Executive Director's Recommendation

Commission Meeting: June 6, 2019

PROJECT National Native American Veterans Memorial National Museum of the American Indian 4th Street and Independence Avenue, SW Washington, DC	NCPC FILE NUMBER 8018
SUBMITTED BY Smithsonian Institution	NCPC MAP FILE NUMBER 1.41(38.00)44926
REVIEW AUTHORITY Pub. L. No. 103-384, §3 (c)(2), 108 Stat. 4067, 4068 (October 22, 1994), as amended and 40 U.S.C. § 8722(b)(1) and (d)	APPLICANT'S REQUEST Approval of preliminary site development plans
	PROPOSED ACTION Approve preliminary site development plans
	ACTION ITEM TYPE Staff Presentation

Section through Railing

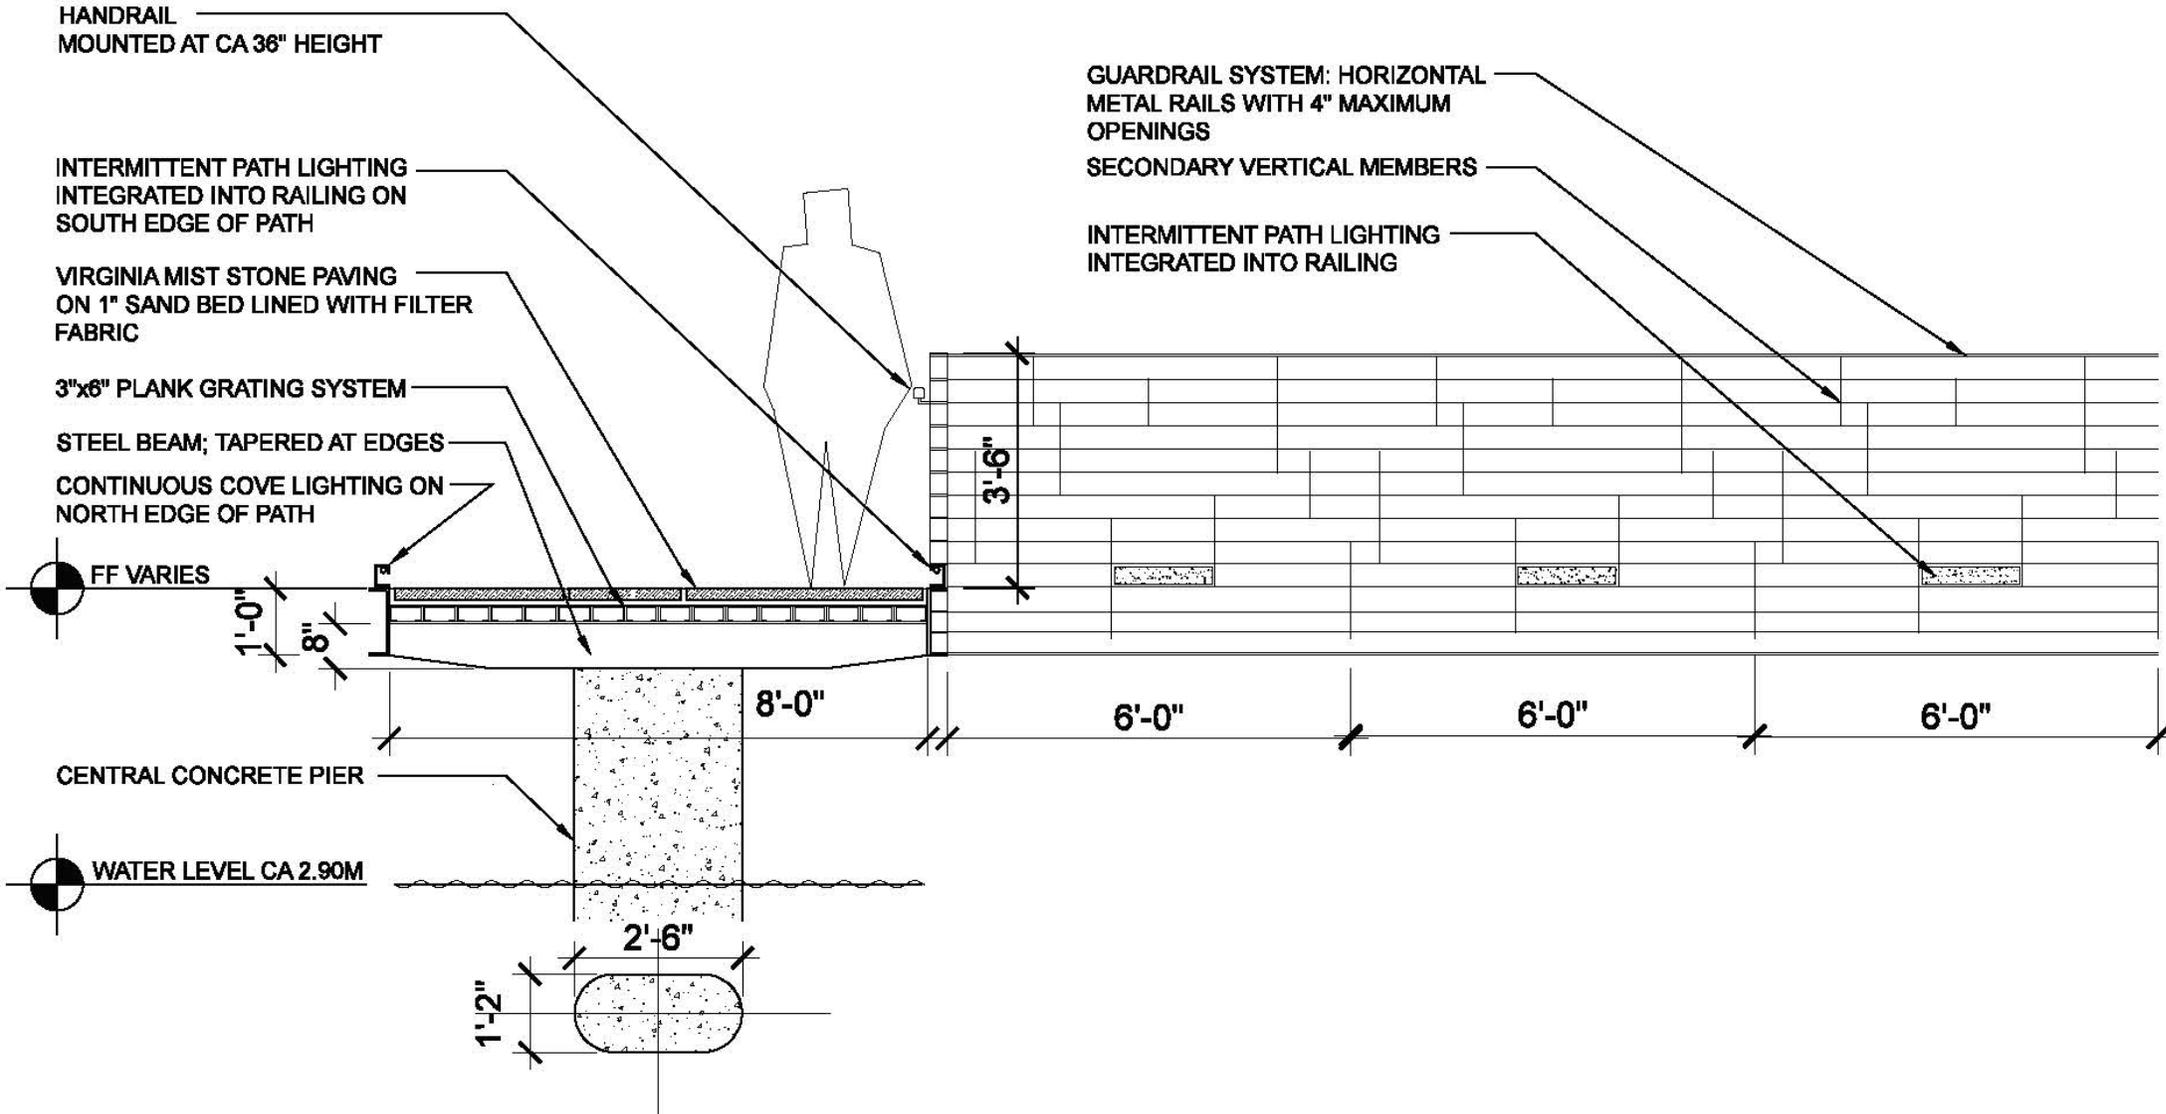
- Simplify the railing design to minimize visual impacts and its heavy composition, and avoid competing with the memorial elements, landscape, and the museum's architecture.
- Protect and restore the wetland's edge biodiversity to enhance the site's ecological quality, scenic character, and prevent erosion.

Inspired by the museum's architecture, the railing design recalls the flutter of falling leaves and glints of reflecting sun. Staff finds that the complex railing diminishes the memorial's simple, light, and elegant design. The busy composition is distracting and competes with the memorial vertical elements, landscape, and the building's distinctive curvilinear form and texture. The railing reflects harsh shadows on the walkways and appears heavy and dense. The railing should be lighter and more transparent to contrast with the solid title wall and seat walls. The railing should serve as a delicate veil that provides views to the surrounding context, similar to the existing landscape veil in front of the museum. Therefore, staff recommends that the applicant **simplify the railing design to minimize visual impacts and its heavy composition, and avoid competing with the memorial elements, landscape, and the museum's architecture**

Wetland Water Feature: Existing Conditions

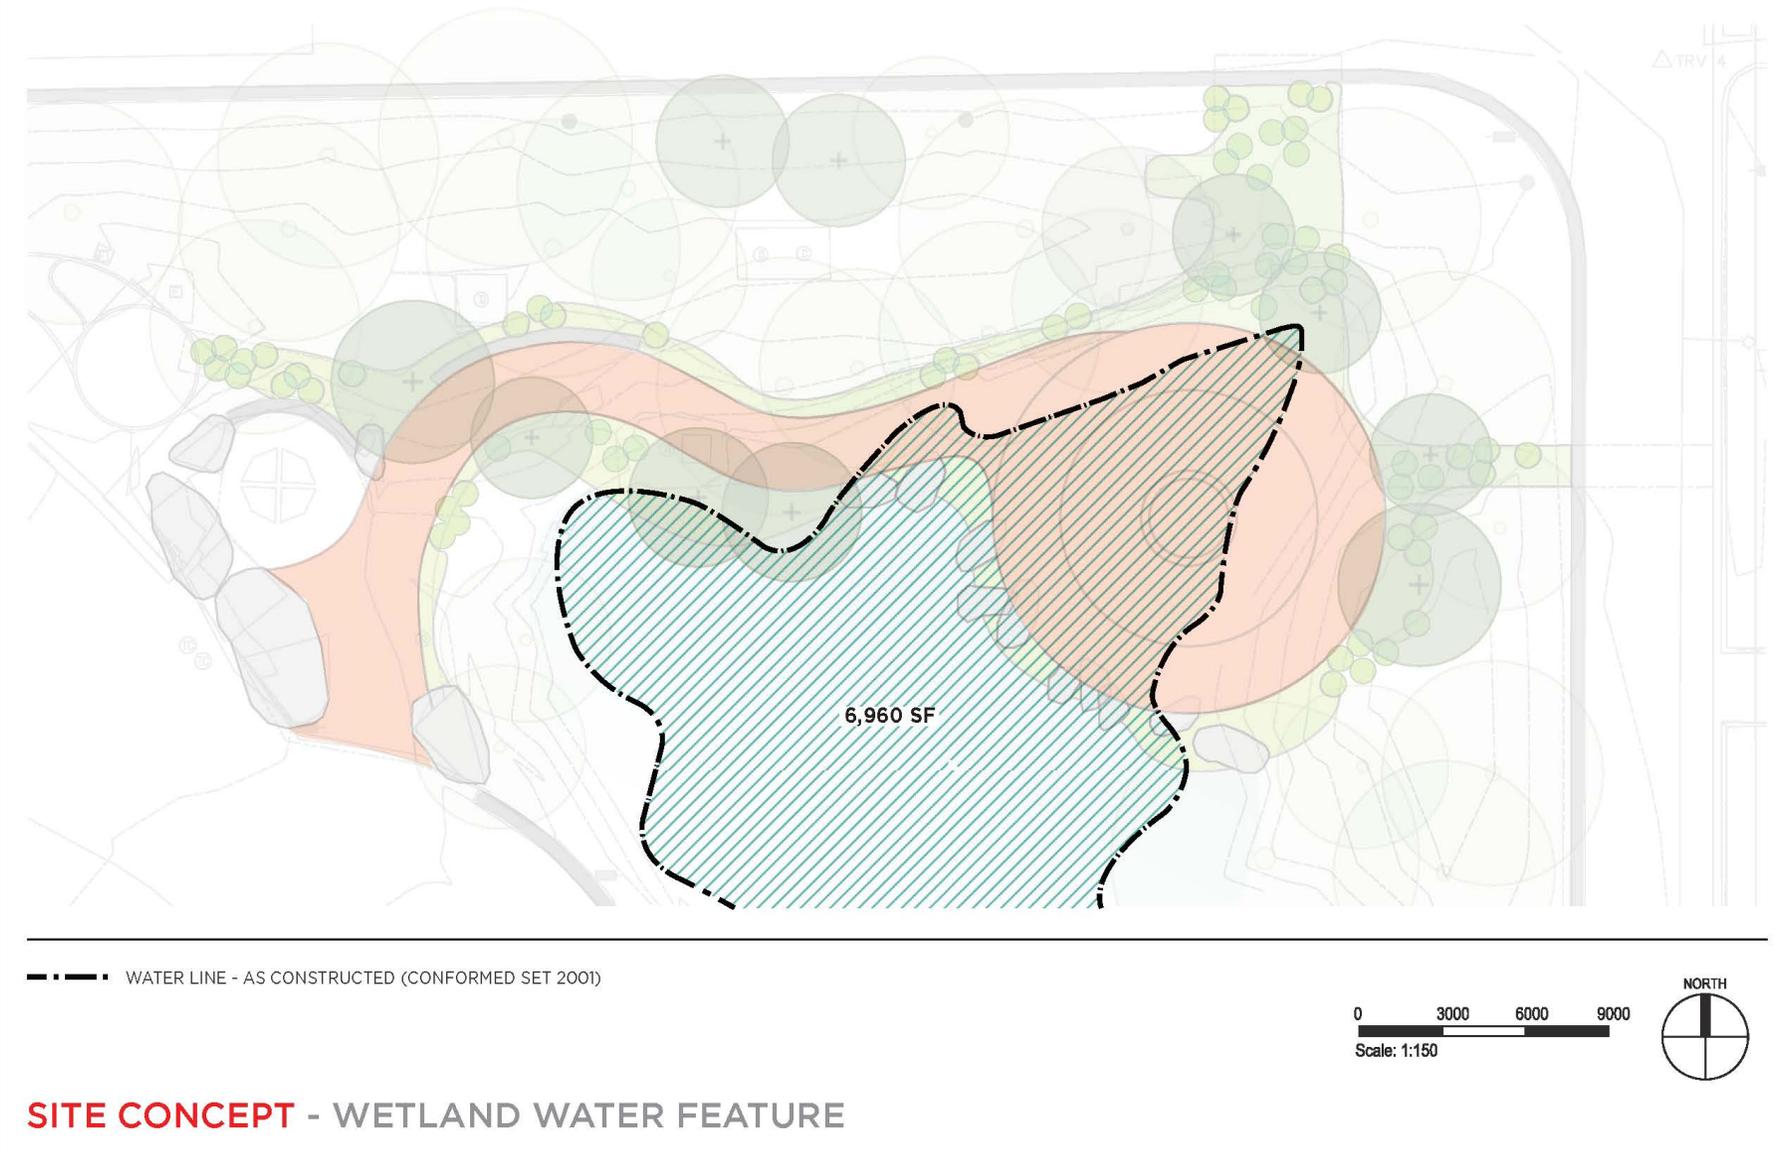
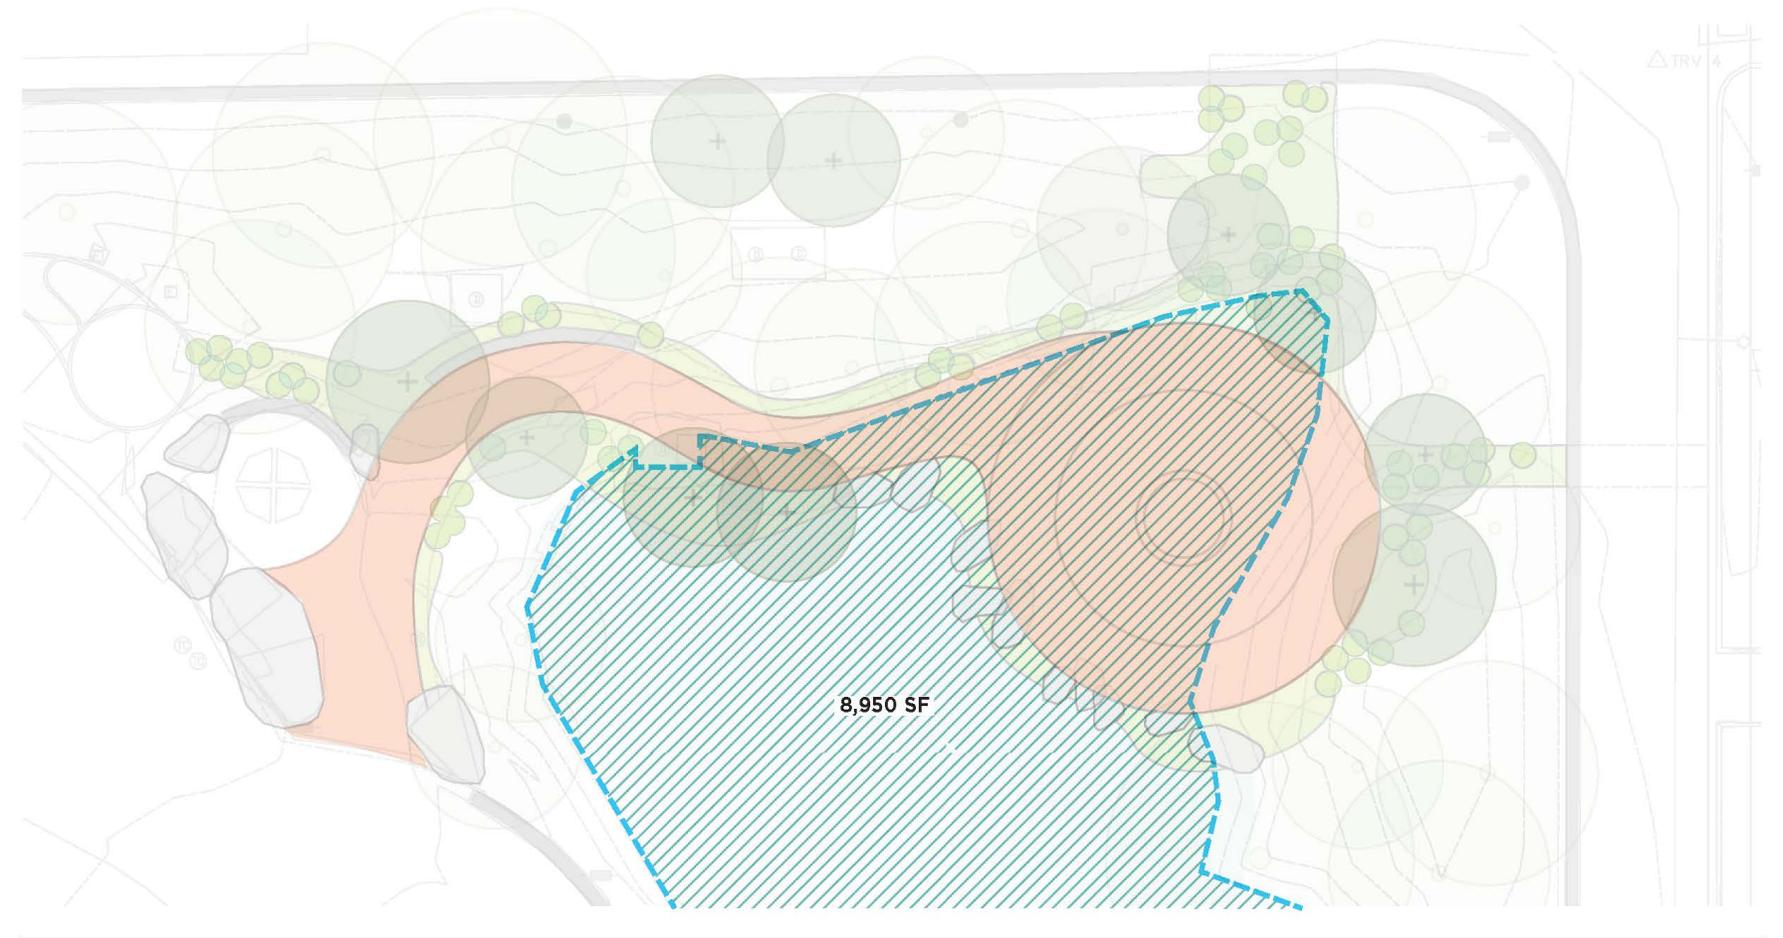
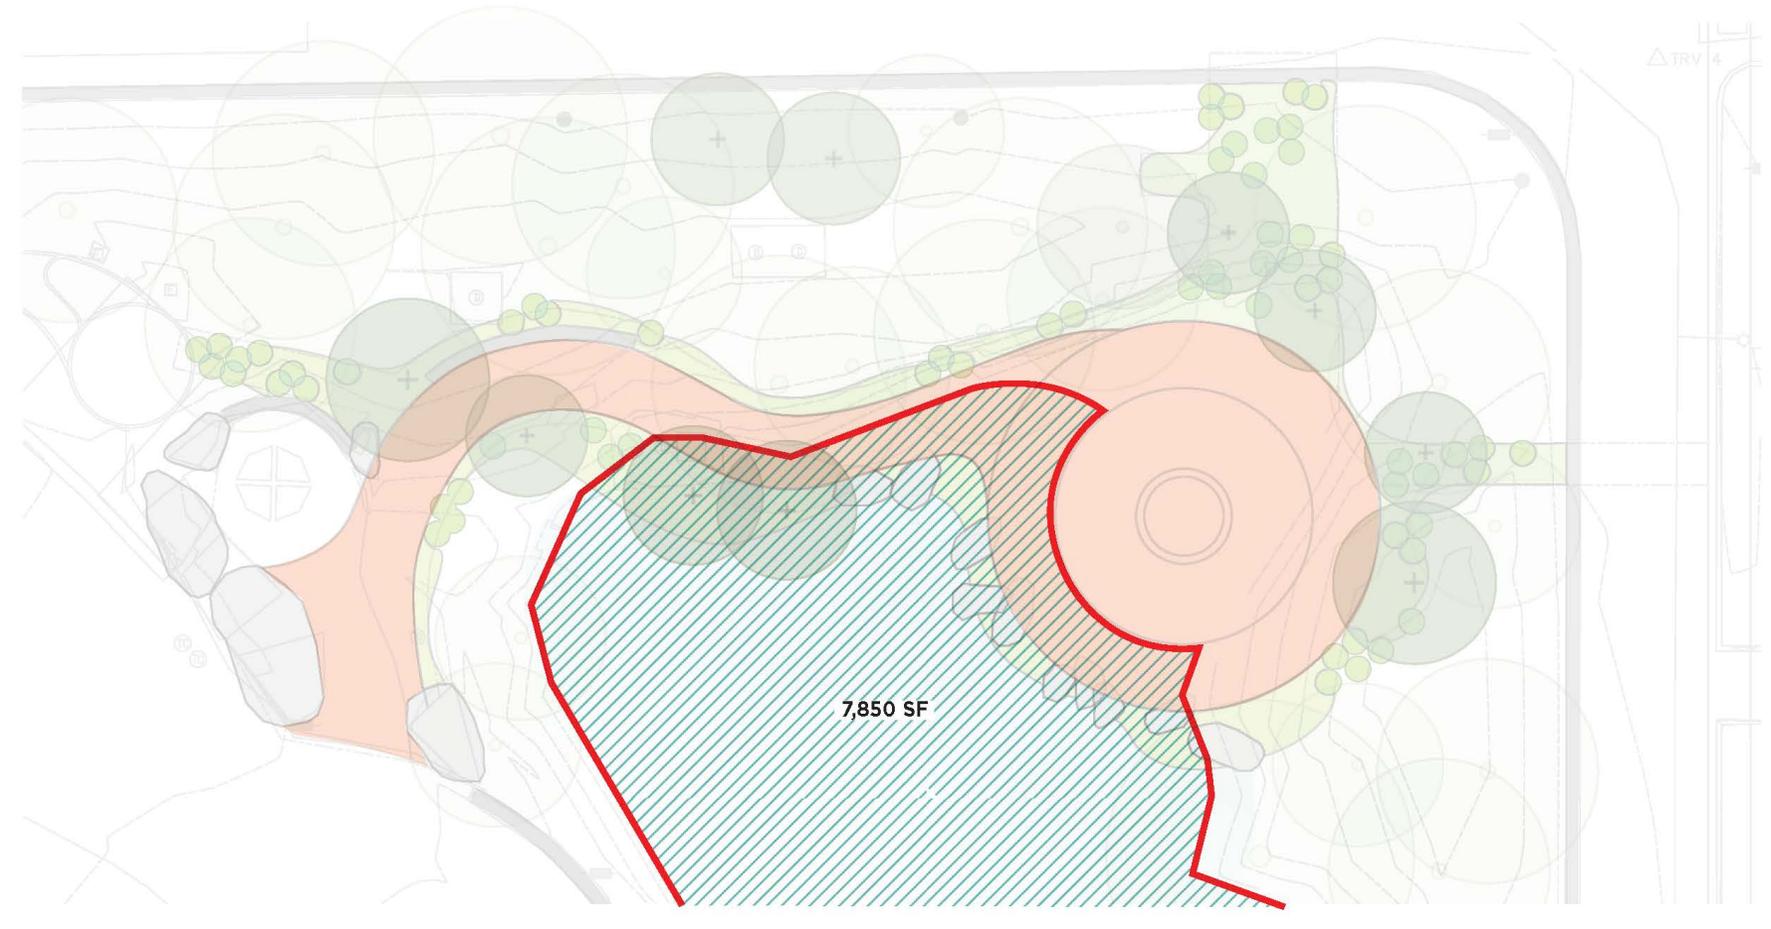
Over the last 15 years, the wetland has grown beyond its original boundaries due to erosion at the banks. The wetland was originally 6,960 square feet based on the 2001 construction drawings. Based on a recent site survey, the wetland is currently 8,950 square feet, approximately 30 percent larger than the original design. The proposed design will reduce the wetland water feature to 7,850 square feet, which is a 12 percent reduction from existing conditions. However, the proposed wetland will be 890 square feet larger than the original 2001 design (12 percent increase).

The project will include edge stabilization to limit the erosion at the north edge of the pond through rocks and deep-rooted plantings. Smithsonian will address the other wetland edges as part of a follow-up wetland restoration and maintenance project within the next 5 years. Therefore, staff recommends that the applicant **protect and restore the wetland's edge biodiversity to enhance the site's ecological quality, scenic character, and prevent erosion.**
